SCHWEIZER SERVICE BULLETIN

B-295.1*
28 Feb 2012

SUBJECT: INSPECTION AND MODIFICATION OF TAILBOOM SUPPORT STRUT ADJUSTABLE DIAMETER BOLT

Figure B-295-1. Tailboom Support Strut Adjustable Diameter Bolt Inspection and Modification

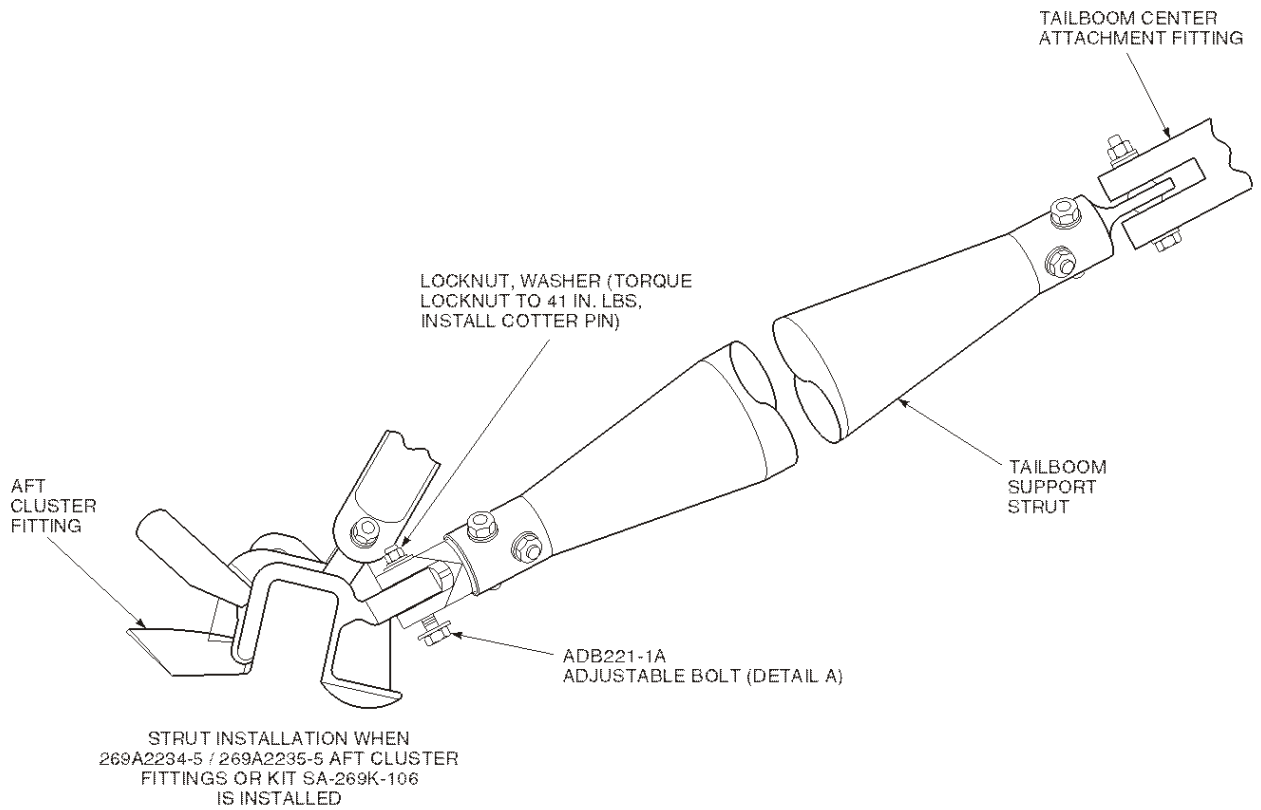
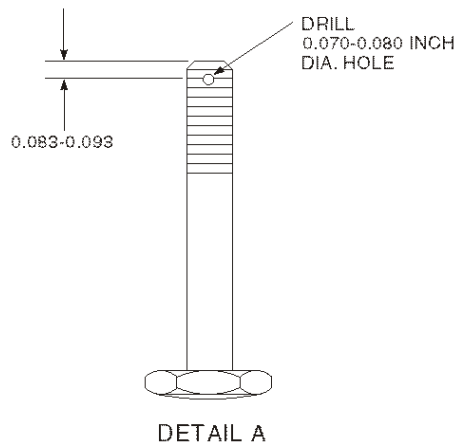
- a. See Figure B-295-1 and note locations of aft cluster fittings and adjustable diameter bolts.
- b. Loosen MS21043-3 locknut and verify turning (drag) torque of at least 2 in-lbs.
 1. If 2 in-lbs. or greater drag torque has been verified, re-torque locknut to 23 in-lbs. plus maximum drag torque of 18 in-lbs. for a final torque of 41 in-lbs.
 2. If drag torque is less than 2 in-lbs., replace with new MS21043-3 locknut and torque locknut to 23 in-lbs. plus a maximum drag torque of 18 in-lbs. for a final torque of 41 in-lbs.
- c. Record compliance with Part I of this service bulletin in the helicopter records.

- a. Remove ADB221-1A adjustable diameter bolt from helicopter.
- b. Modify bolt as follows:
 1. Remove bolt from adjustable assembly and retain all parts.
 2. Secure bolt in drill vise.
 3. Using a drill press, drill 0.070-0.080-inch diameter hole through threaded portion of bolt, centered 0.083-0.093-inch from end of bolt as shown in Figure B-295-1.
 4. Chase threads of bolt to remove any burrs.

- c. Reassemble washer and bushings onto bolt in accordance with Basic HMI, Section 11.
- d. Install adjustable diameter bolt (Basic HMI, Section 11).
- e. Install new MS21043-3 locknut on bolt and torque locknut to 23 in-lbs. plus a maximum drag torque of 18 in-lbs. for a final torque of 41 in-lbs.
- f. Install MS24665-132 or MS24665-151 cotter pin on adjustable diameter bolt.
- g. Record compliance with Part II of this service bulletin in the helicopter records.
